# SITE DEVELOPMENT PLANS

## LISCIOTTI DEVELOPMENT CORP.

LOCATION OF SITE:  
30 WILTON ROAD, TOWN OF MILFORD  
HILLSBOROUGH COUNTY, NEW HAMPSHIRE  
MAP #6, LOT #14

**DOLLAR  
GENERAL  
MILFORD,  
NH**

SHEET TITLE:  
**LANDSCAPE PLAN**

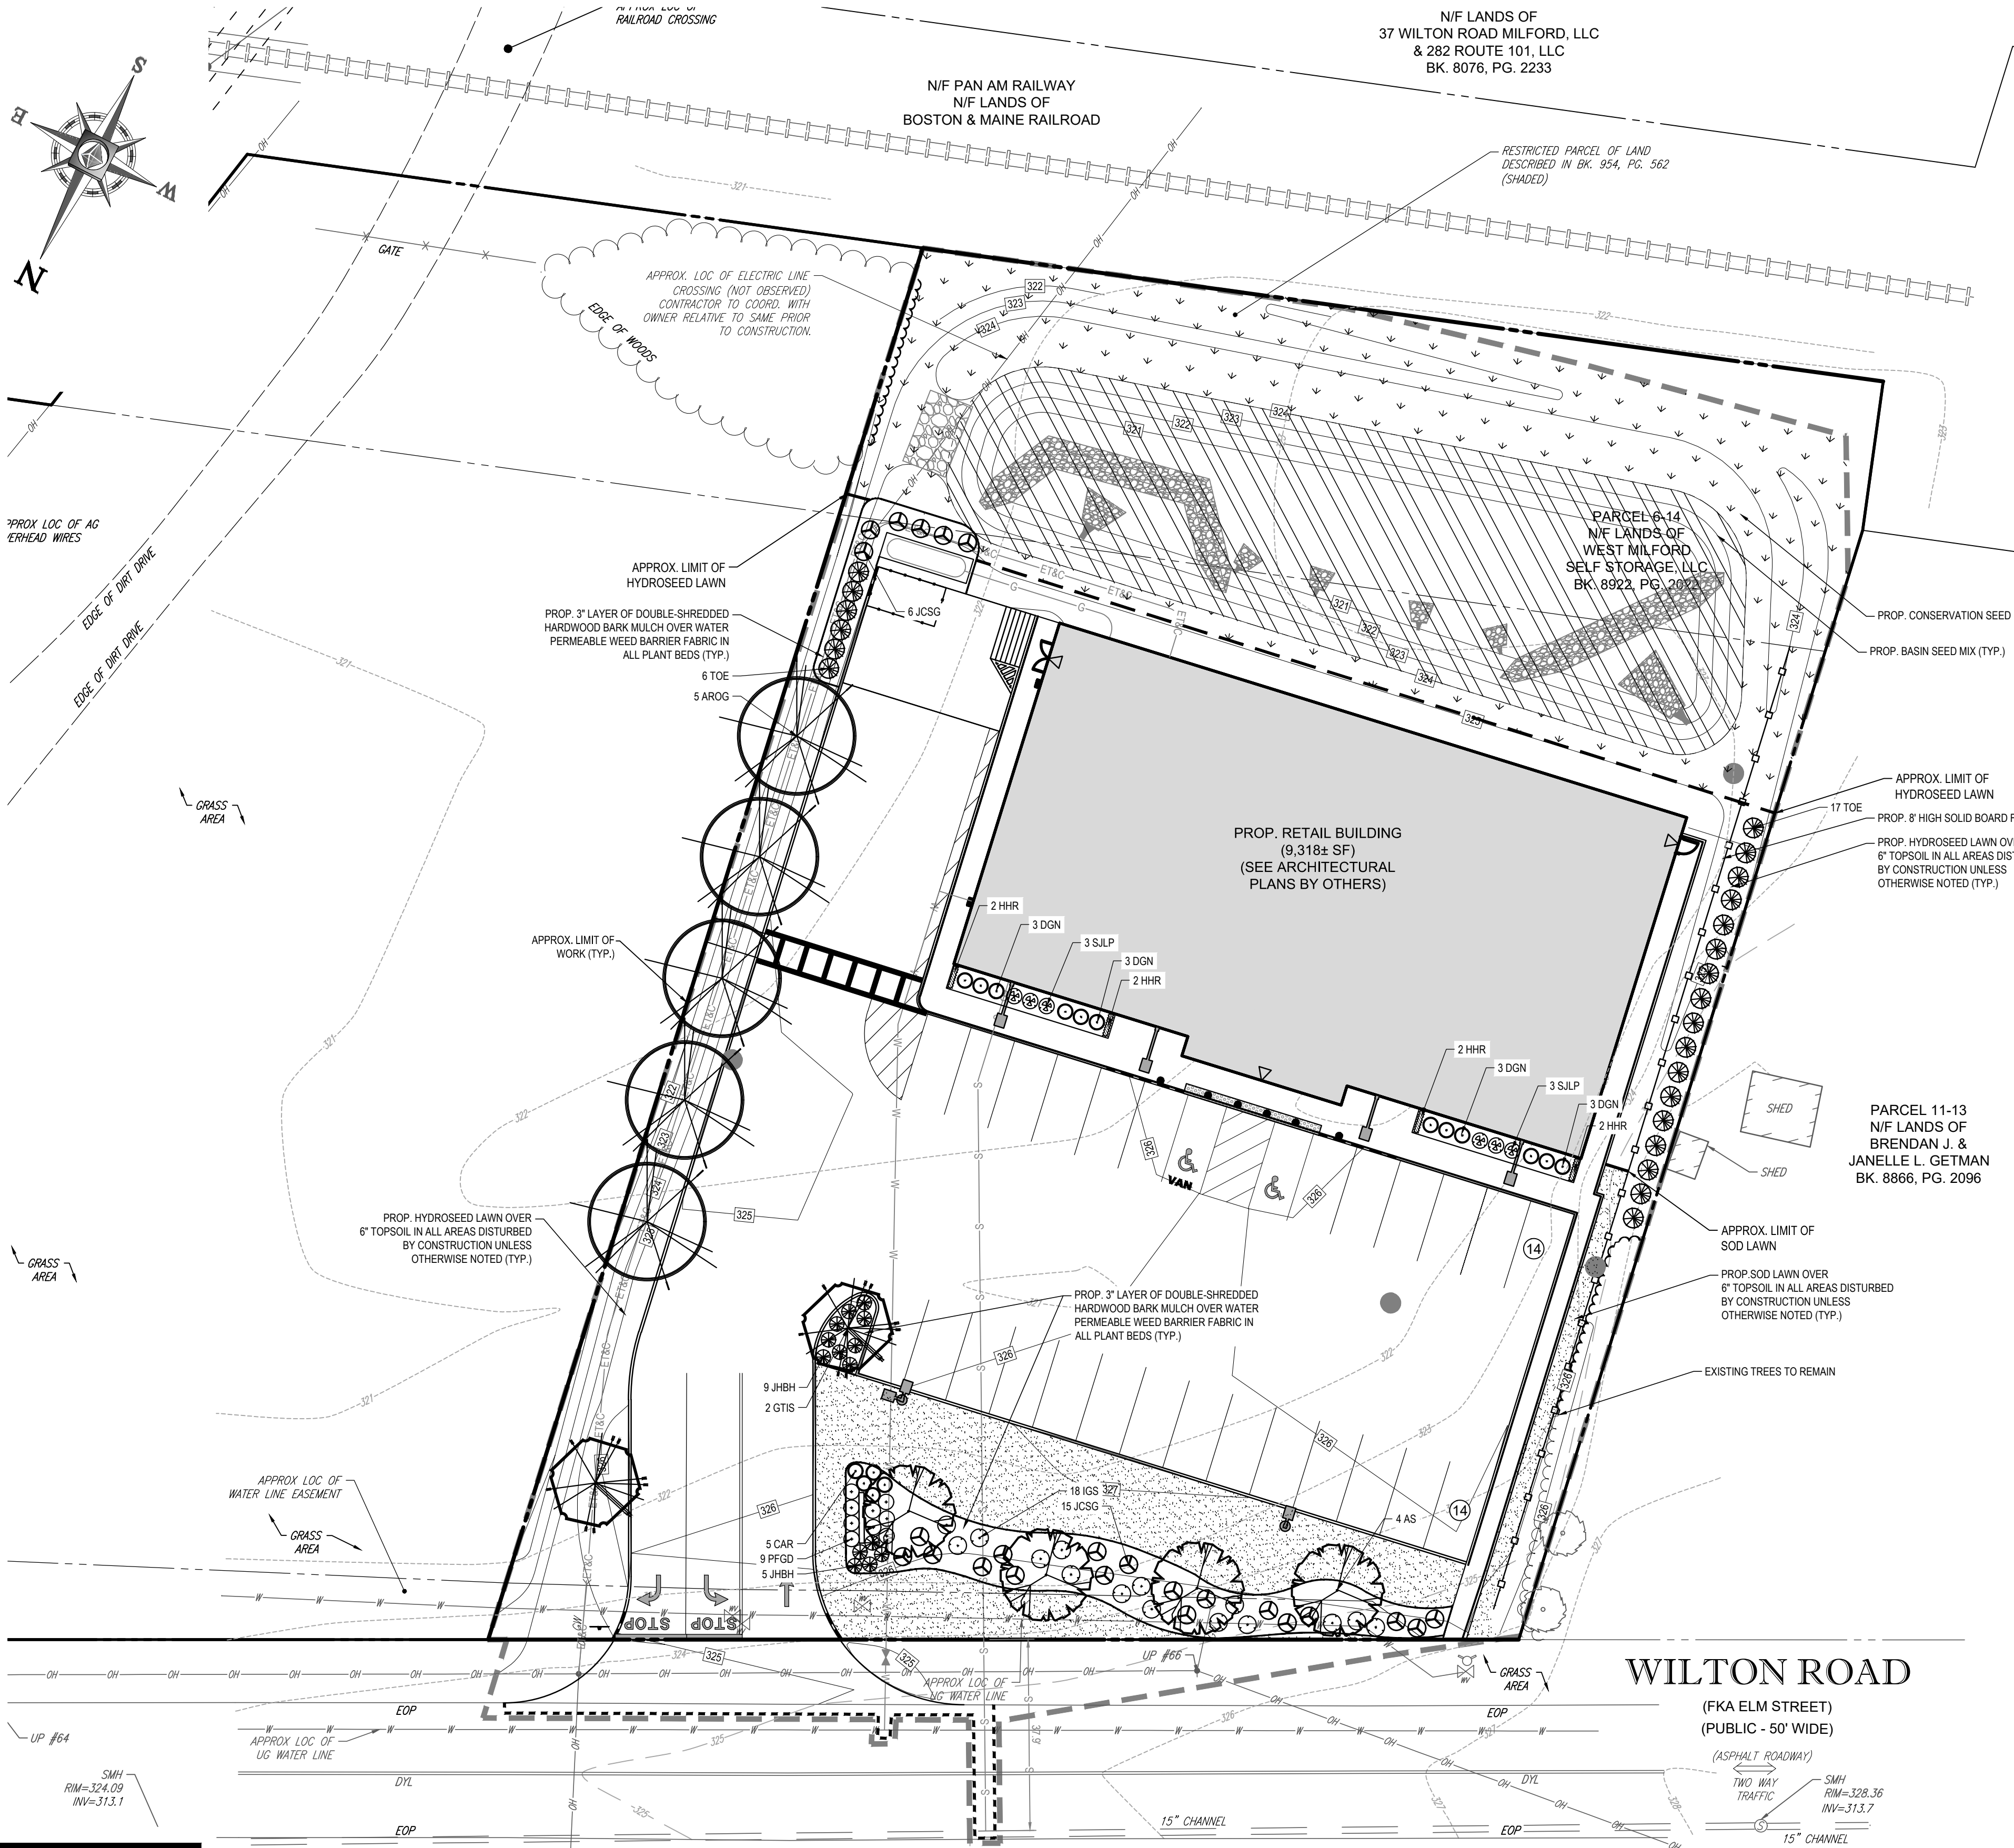
**Comment 11:** *Sheet 9, Irrigation Notes. The plan states that all landscaped areas and lawns are to be fully irrigated. Further, the irrigation system would be designed by other and include all spray heads, valves and controllers. Please refer to Section 6.08.2 of the Development Regulations detailing the requirements for a permanent irrigation system and revise the plans accordingly.*

**Comment 12:** *Sheet 9. The proposed landscape design does not currently include any plantings along the building. Pursuant to Section 6.08.6 of the Development Regulations, landscaping shall be provided along all building frontage. A minimum of one (1) shrub for every five (5') feet of building frontage shall be provided. In instances where it is not possible to locate all required shrubs along the building frontage due to doorways, walkways or other impervious surfaces, the required shrubs shall be utilized within the parking lot or landscape buffers. Please revise the plan accordingly or submit a waiver request.*

**Comment 13:** *Sheet 9. Pursuant to Section 6.08.8.A of the Development Regulations, please confirm that all plant stock meets the ANSI Z60.1 standard.*

**Comment 14:** *Sheet 9. Please add a note to the plan stating the following, "Any landscape element that dies, or is otherwise removed, shall be promptly replaced with the same, if not similar to, height or texture*

**Response 11:** **The plans have been updated such that permanent irrigation systems, if provided, shall be low volume systems and utilize water saving technologies, as shown on Sheet 9 of the enclosed Site Development Plans.**

**Response 13:** **All plant stock is proposed to meet ANSI Z60.1, a note stating same is included on the enclosed Site Development Plans.**

- Response 14:** The requested note has been added the Landscaping Plan included as part of the enclosed Site Development Plans.
- Comment 15:** *Sheet 11, Stockade Fence Detail. Please revise the plans by replacing the vinyl coated chain link fence along the front of the dumpster pad with the wooden slat detail and adjust the gate design accordingly.*

STONE CHECK DAM DETAIL

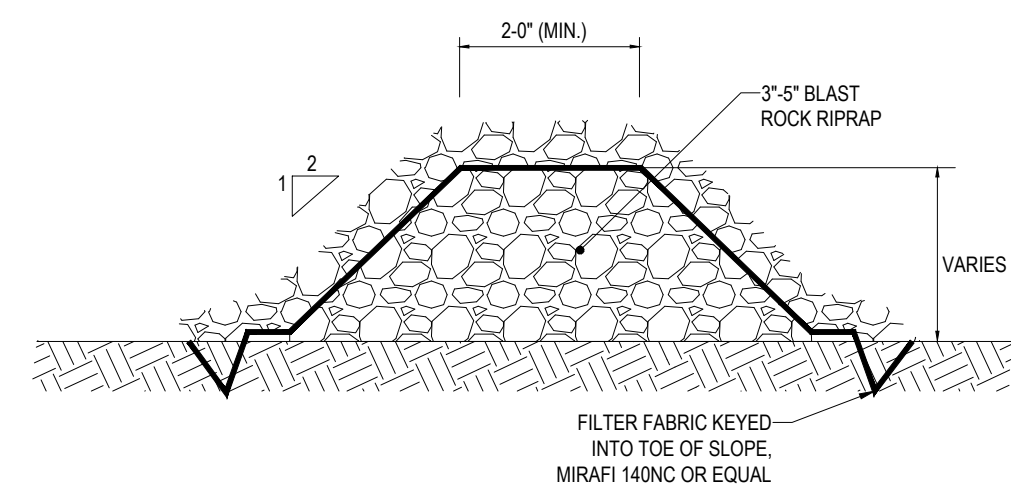
*Comment 3: Sheet 13 Stone Check Dam Detail. Revise the detail by removing the filter fabric.*

**Response 3: The Stone Check Dam Detail has been revised as requested, as shown on Sheet 13 of the enclosed Site Development Plans.**

WALL SIGN DETAIL

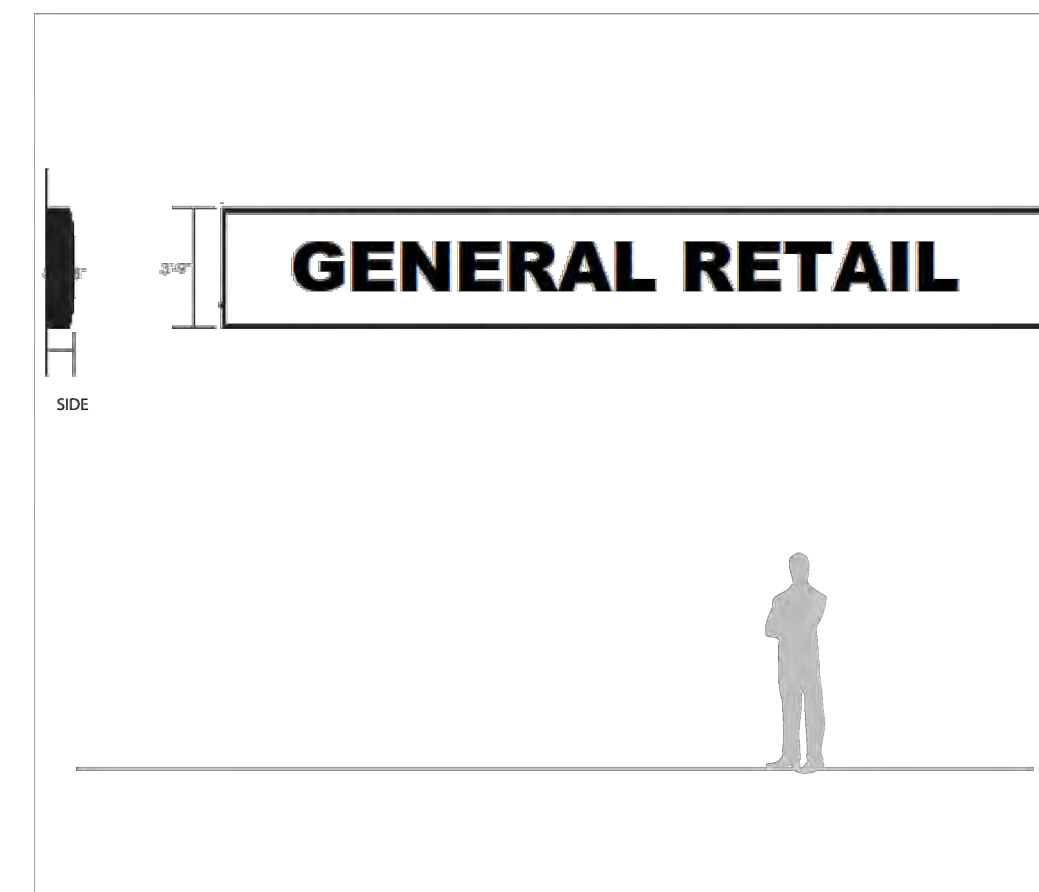
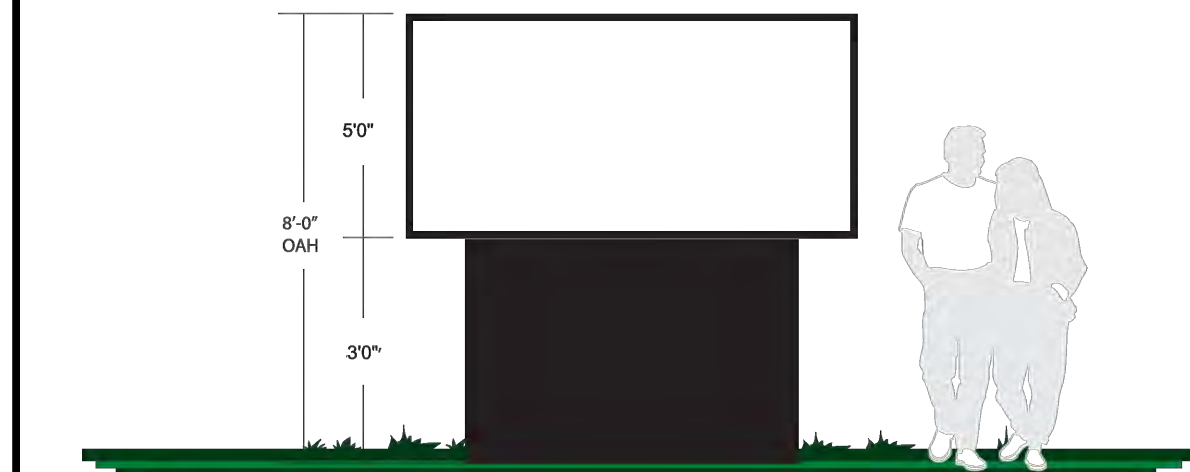
*Comment 7:* Sheet 4. Proposed Signage. Please include the proposed design, construction, and engineering details associate with the monument sign, directional signage, and wall signage. Recommended placement of information on Sheet 13.

**Response 7:** Details representative of the anticipated monument and building signage has been included on Sheet 13 of the enclosed Site Development Plans. Final signage details are anticipated to be completed by the proposed tenant and provided to the Town prior to construction.

**Response 25:** **Details representative of anticipated monument and building signage has been included on Sheet 13 of the enclosed Site Development Plans. Final signage details are anticipated to be completed by the proposed tenant and provided to the Town prior to construction.**
